Final Supplemental Environmental Impact Report for the Downtown San Diego Mobility Plan, San Diego, California SCH #2014121002

Downtown San Diego Mobility Plan Final Supplemental Environmental Impact Report

The City of San Diego (City), as the lead agency under the California Environmental Quality Act (CEQA), has prepared this Final Supplemental Environmental Impact Report (Final SEIR) for the Downtown San Diego Mobility Plan and associated amendments to the Downtown Community Plan which include the replacement of Chapter 7 Transportation with a new Chapter 7 Mobility and a revised MMRP as Attachment A (proposed Project). This Final SEIR contains all of the required contents as outlined in Section 15132 of the CEQA Guidelines, including: revisions to the Draft SEIR, comments received on the Draft SEIR, a list of persons, organizations, and public agencies commenting on the Draft SEIR, responses of the lead agency; and any other information added by the lead agency.

Figure 3-3 Planned Bicycle Network

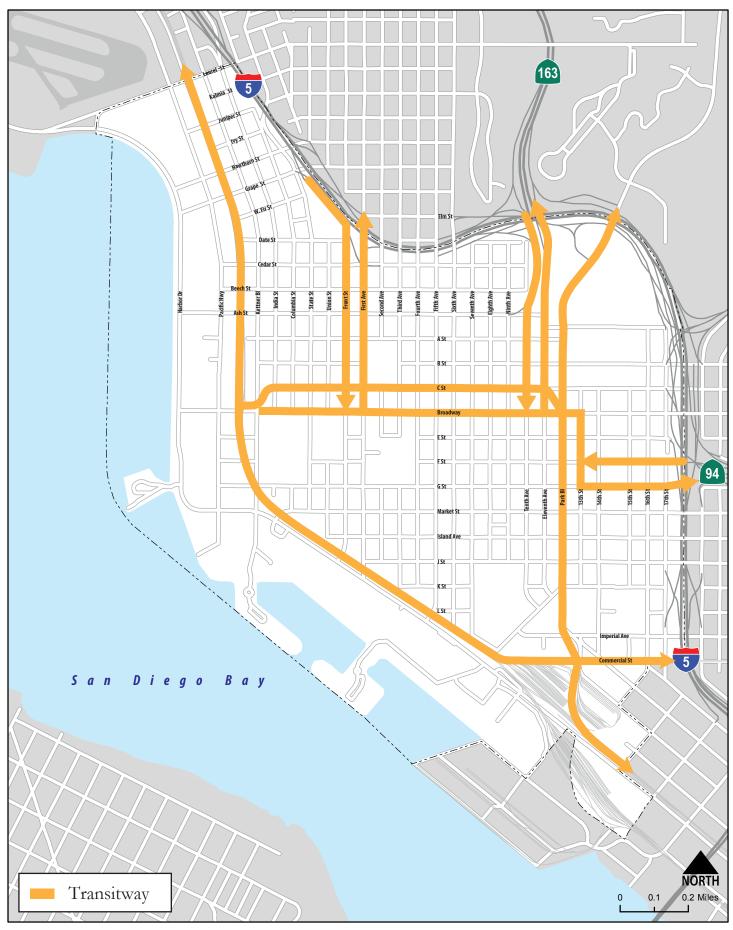
- Figure 3-3: Planned Bicycle Network and Figure 4.2-1: Existing Bicycle Facilities in the Final SEIR were revised to reflect the MLK Promenade running along the south side of the tracks, from Park Boulevard to Fifth Avenue. The gap exists along the north side of the tracks from Fifth Avenue to Sixth Avenue due to the pedestrian plaza.
- Figure 3-6: Road Diets Accommodating Complete Streets was revised to show Park Boulevard, from Market Street to Island Avenue, will remain open to vehicular traffic to facilitate commercial deliveries and provide additional on-street parking.
- Figure 4.2-2: Existing High Frequency Transit Network has been updated to correctly show Route 215 which operates on Broadway and Park Boulevard.
- Figure 4.2-3: Existing Transit Frequency was revised to show the current alignment for Route 215 which operates on Broadway and Park Boulevard.

In response to this comment, Figure 5-2 Proposed Bicycle Network includes existing Class III on Kettner from A Street to Kalmia Street, and planned Class III from Kalmia Street to Laurel Street. Figure 5-2 in the Mobility Plan, Figure 3-3 and Figure 4.2-1 in the SEIR were revised to reflect the Martin Luther King, Jr., Promenade running along the south side of the tracks, from Park Boulevard to Fifth Avenue. The gap exists along the north side of the tracks from Fifth Avenue to Sixth Avenue due to the pedestrian plaza.
